STAFF REPORT: 05/14/2025 MEETING

ADDRESS: 4015 GLENDALE

APPLICATION NO: HDC2025-00065

SCOPE: REPLACE STEEL CASEMENT WINDOWS (WORK COMPLETED WITHOUT APPROVAL)

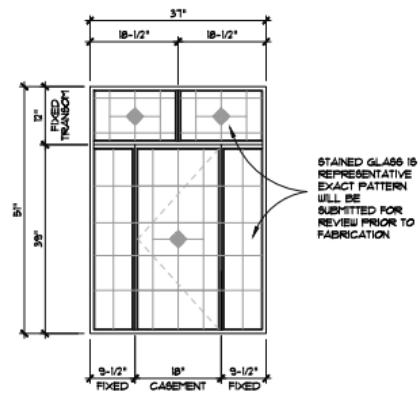
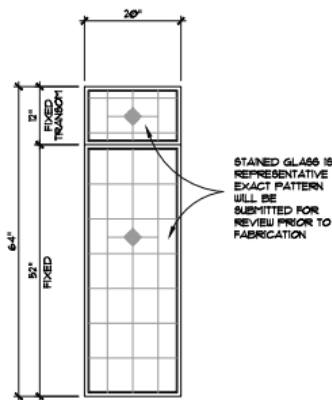
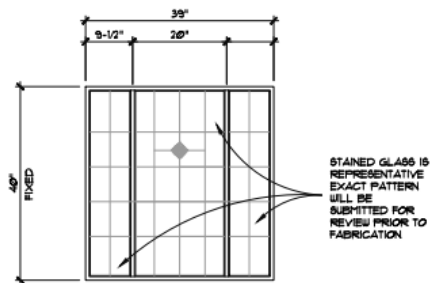
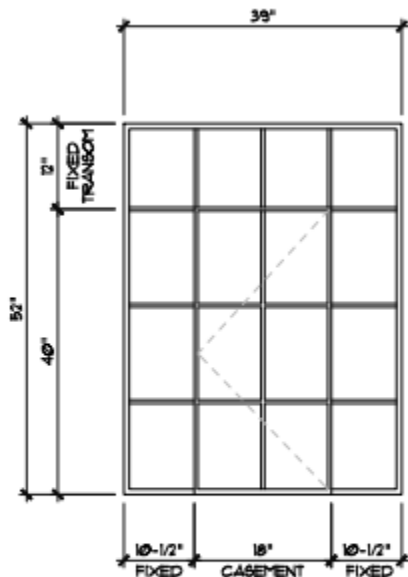
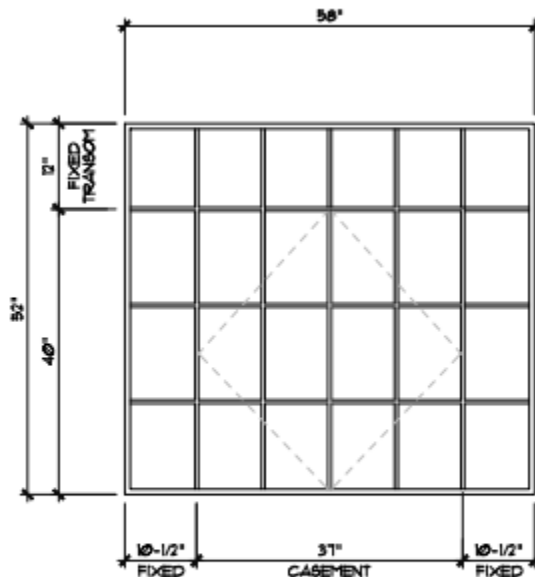
- See the below submitted drawings which depict the new windows which will be installed at the front façade to replace those which were removed. While the new steel casement labeled F and G generally appear to match the original, the more decorative windows, labeled A, B, and C, do not clearly indicate that the windows will include lead coming to match the original. Should the Commission approve this work item (replace original windows at the front façade per the submitted application), staff recommends that they do so with the condition the applicant provide clear documentation of the design of the windows prior to their removal, the new windows exactly match the original in operation, material, design, and dimension, and that staff be afforded the opportunity to review and approve the final proposal prior to issuance of the permit.

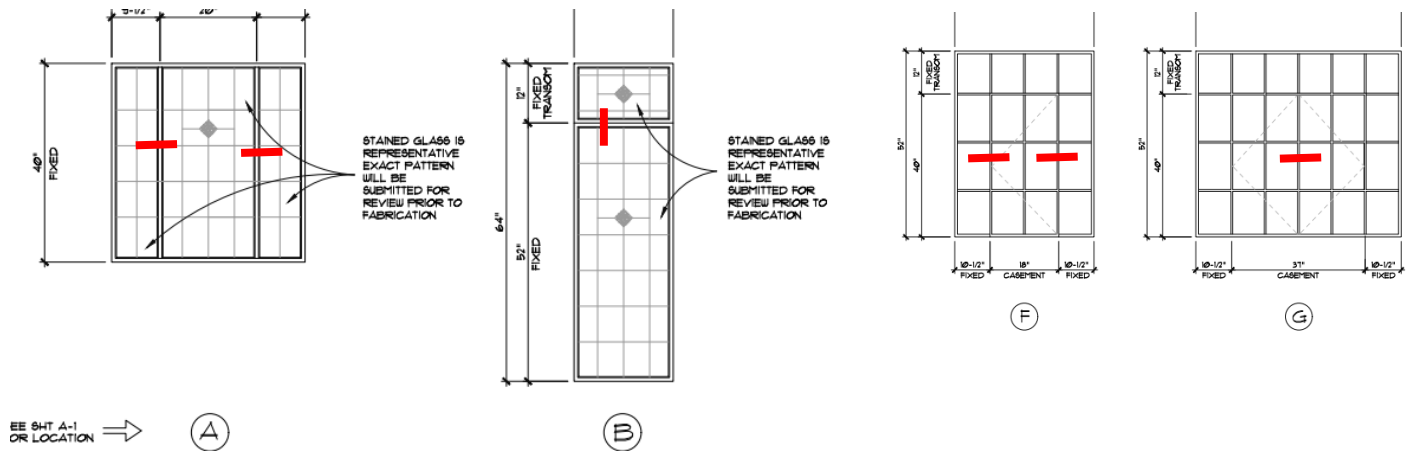
- Staff also recommends that the applicant provide typical dimensioned section detail drawings at the mullions/at each of the below indicated areas (indicated in red) to ensure the new windows will adequately match the historic units should the Commission approve the windows proposed for installation at the front facade:
